ENVIRONMENTAL NOISE ASSESSMENT ADDENDUM FOR ANGLIA SQUARE, NORWICH

ENV01-ANGL-049 – Anglia Square, Norwich

Environmental Noise Assessment Addendum: Comments on Norwich City Council Environmental Protection Team Response on ENA (NCC Ref: 18/00330/F)

Pitt Street elevation

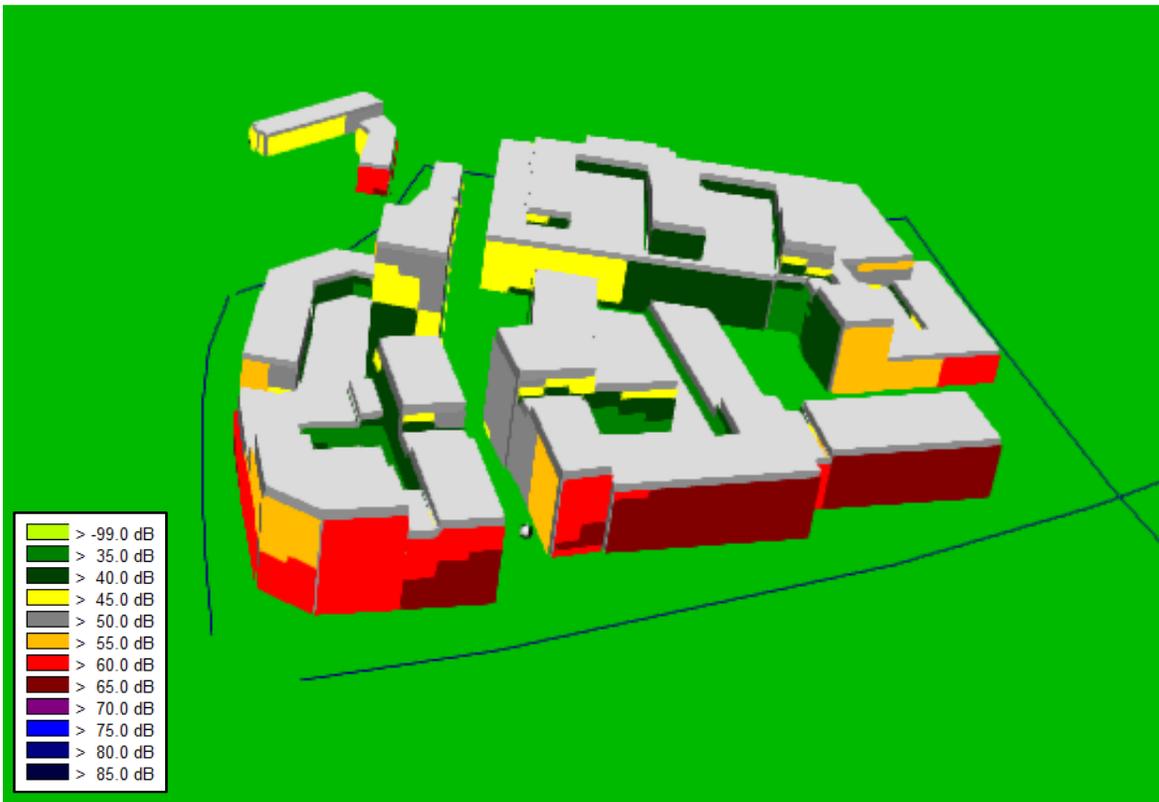
- 5. A number of the proposed residential apartment blocks will have building facades located close to the highway on Pitt Street, New Botolph Street, and St Crispins Road. The noise levels at the facades of these buildings are likely to be significantly higher than those suggested by SES in their submitted ENA. The fixed and spot noise measurements that have been used during the noise survey could have been expanded to include positions much closer to the highway giving more representative building façade noise levels.**

The measurement positions were deemed satisfactory as the fixed noise monitoring positions targeted (Position 1) the St Crispins Road elevation of the proposed development (identified as the primary noise source affecting the site) with Position 2 being a more central position. Seven spot monitoring measurements were also take for thirty minute periods around the boundary of the site which correlated well with the data collected by the fixed monitoring stations.

CadnaA modelling has now been carried out to assess the noise levels at the building facades. Copies of the models have been attached.

As can be seen from the models, the highest daytime level of noise at the facades are within the >65dB banding which correlates with the 67.2dB level referred to in the ENA. This is further broken down as follows;

- Maximum façade levels on the Pitt Street/New Botolph Street elevation elevation = >60dB
- Maximum façade levels on the Edward Street = >65dB
- Maximum façade levels on the St Crispins Road elevation = >65dB
- Maximum façade levels on the Magdalen Street elevation = <60dB

As such, the level of attenuation required remains 32dB as stated within the ENA at the noisiest elevations.

St Crispins Road elevation

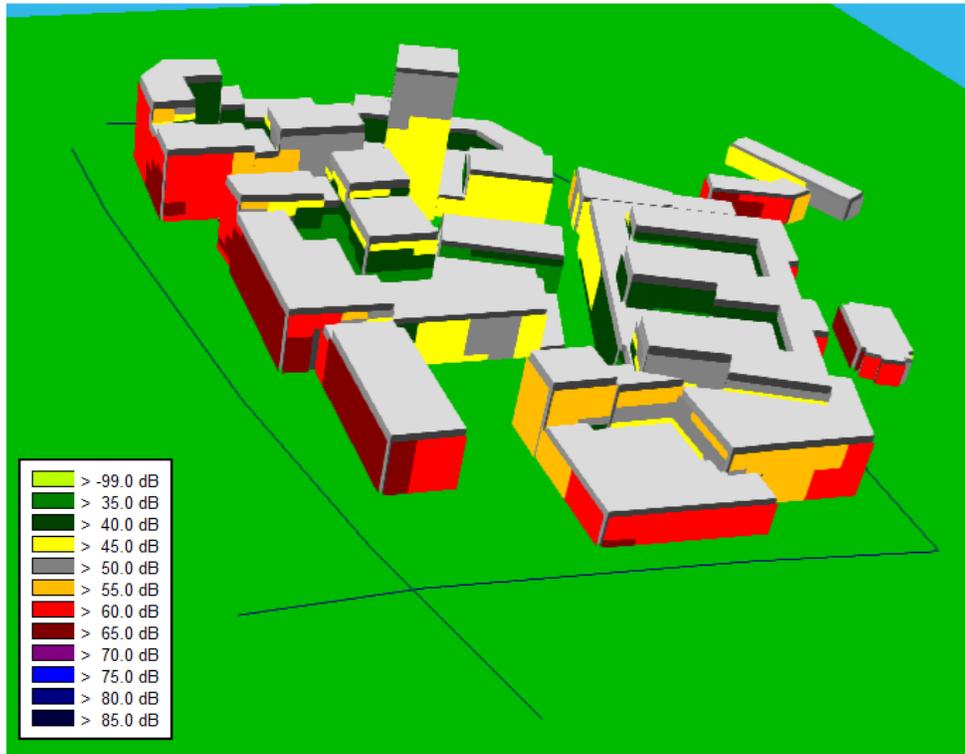
8. ***As a consequence, the building envelope including glazing elements for the block facing the St. Crispins Road will need to be carefully selected to ensure there is sufficient protection from road traffic noise for the occupiers of the proposed residences or otherwise consider alternative uses for this block such as office, leisure etc.***

The southern end of Block F, fronting St Crispins Road between the roundabout and the new St George's Street is already proposed as a hotel. It is proposed that this building will be served by an air source heat pump heating/cooling ventilation system, so windows can be sealed, and specified with appropriate attenuation. Blocks G and J, facing St Crispins Road are set further back and as the CadnaA models demonstrate, noise levels at their respective facades can be adequately attenuated by standard double glazing with acoustic trickle vents. The specification can be approved by NCC via planning conditions.
